UNITED STATES
NUCLEAR REGULATORY COMMISSION
WASHINGTON, D. C. 20555

The Commission has issued the enclosed Amendment No. 90 to Facility Operating License No. DPR-65 for Millstone Nuclear Power Station, Unit 2, in response to your application dated April 13, 1983, and supplements dated June 2, July 1, August 12, September 15, November 2, 4, and 17, and December 1, 1983. These changes reflect changes to the Technical Specifications necessary for plant operation in Cycle 6. These changes include:

NORTHEAST NUCLEAR ENERGY COMPANY
THE CONNECTICUT LIGHT AND POWER COMPANY
THE WESTERN MASSACHUSETTS ELECTRIC COMPANY
DOCKET NO. 50-336
MILLSTONE NUCLEAR POWER STATION, UNIT NO. 2
AMENDMENT TO FACILITY OPERATING LICENSE

Amendment No. 90
License No. DPR-65

FIGURE 2.1-1 Reactor Core Thermal Margin Safety Limit -- Four Reactor Coolant Pumps Operating

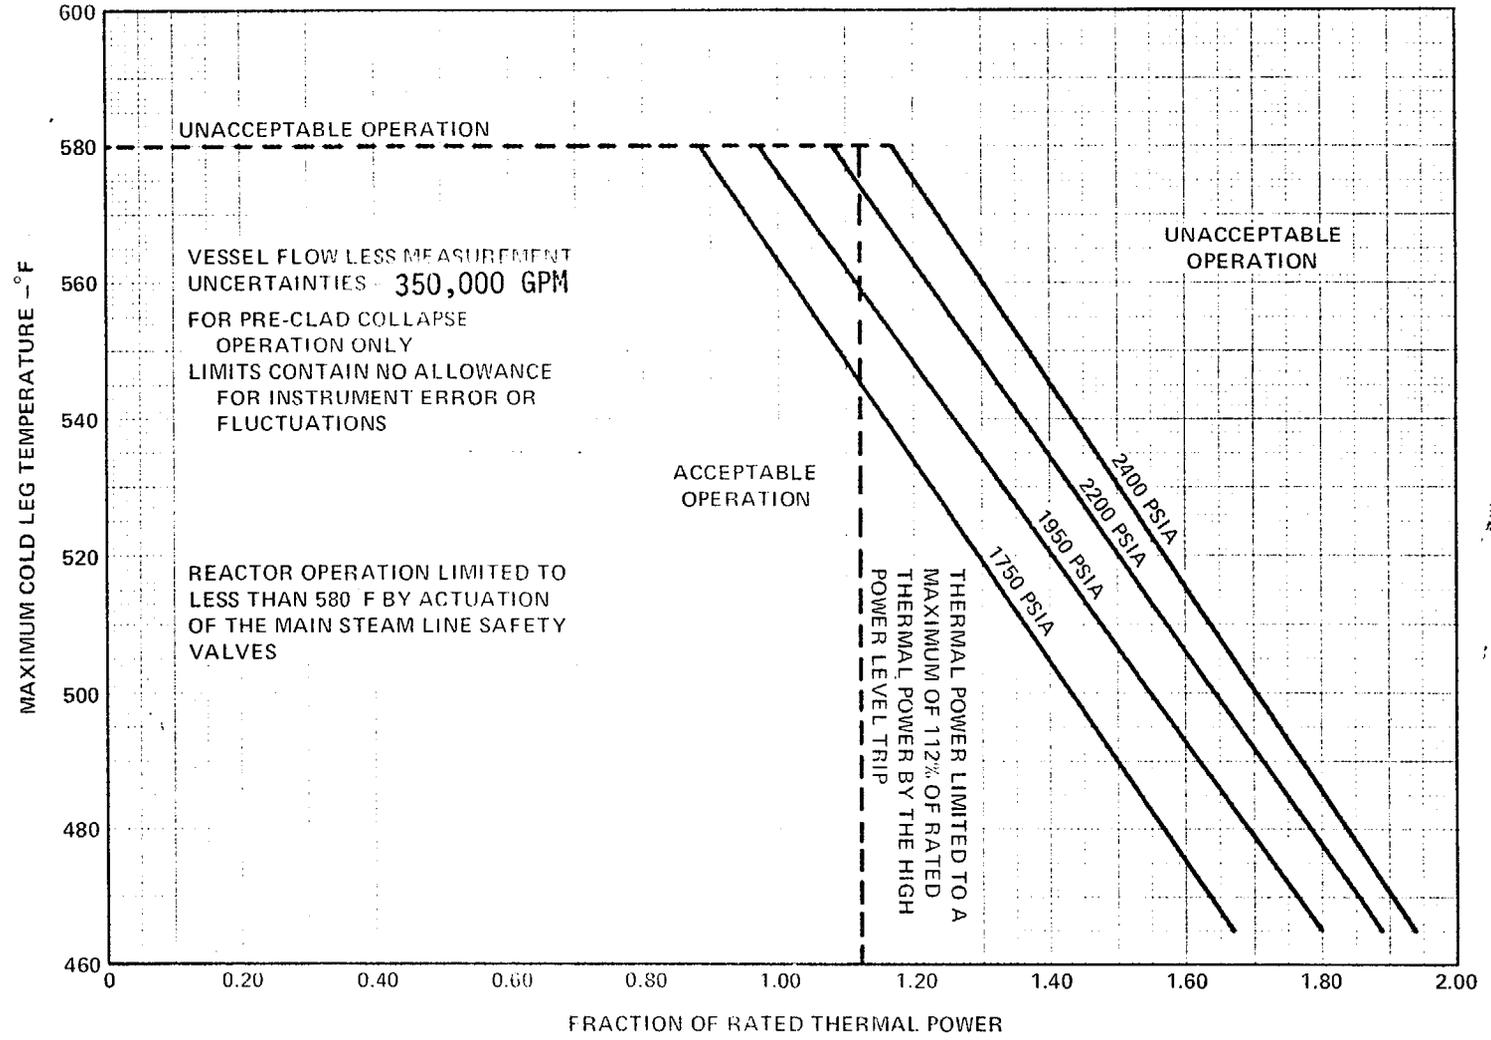
- A. Reduced Reactor Coolant Flow Rate - This proposed change affects pp. 2-2, 2-4, and 3/4 2-14 of the Technical Specifications. It involves lowering the required primary coolant flow rate from 362,500 gpm to 350,000 gpm. This new lower flow is established to correspond to a plugging level of 2500 steam generator tubes, and was used in the Cycle 6 analysis. We find it acceptable since it was offset by the reduction in F_r .

2.1.1 The combination of THERMAL POWER, pressurizer pressure, and maximum cold leg coolant temperature shall not exceed the limits shown on Figure 2.1-1.
